Please upload onto Ocella the email below which is a representation from a **local resident** objecting to reserved matters application **A/109/20/RES** relating to Land South of Water Lane, Angmering.

I refer to the above captioned Planning Application. I have already placed a general objection to this, and now wish to further that from a personal position. On the revised plans of the development which shows a greater density of houses, I draw your attention to Plot 33. The site plan copied below shows the position of the planned house in relation to my property. From this I have approximated the position of the building in relation to my greenhouse and garage. I have placed the loungers shown in the photos below as the approximate position of the planned house. The photos are taken from The Malt House garden facing North.

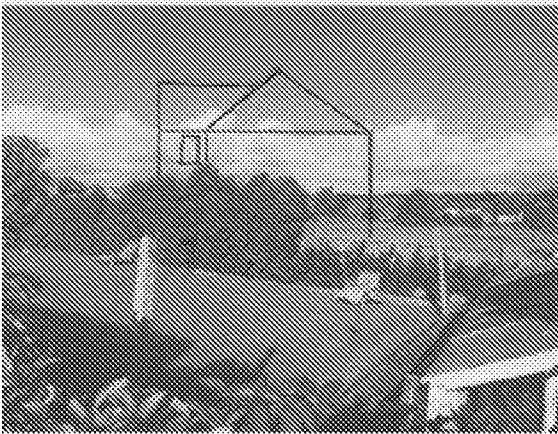
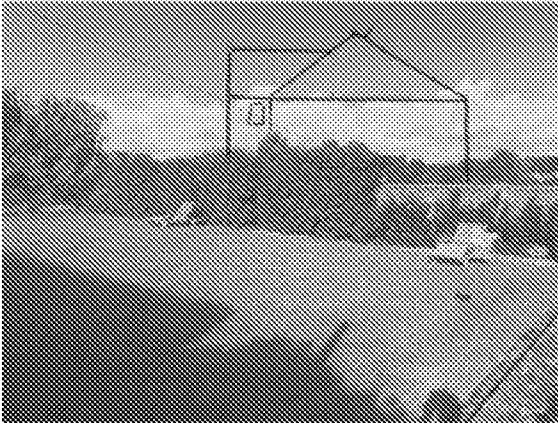
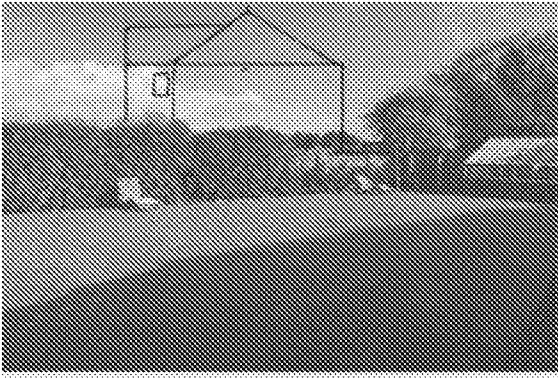
From the architects elevation I have tried to show the impact of the south flank on my property. My wall is 1.6m high, the house wall is 5m + 3m roof, total of 8m, so I have tried to draw the proposed building in relation to the wall height. The plan shows the proposed house being built very close to my garden wall.

I trust you will agree that this cannot be allowed so close to one of the oldest houses in the conservation area, and that this application will be refused in its entirety. Apart from the position of the house, the architecture shows absolutely no sympathy with its surroundings.
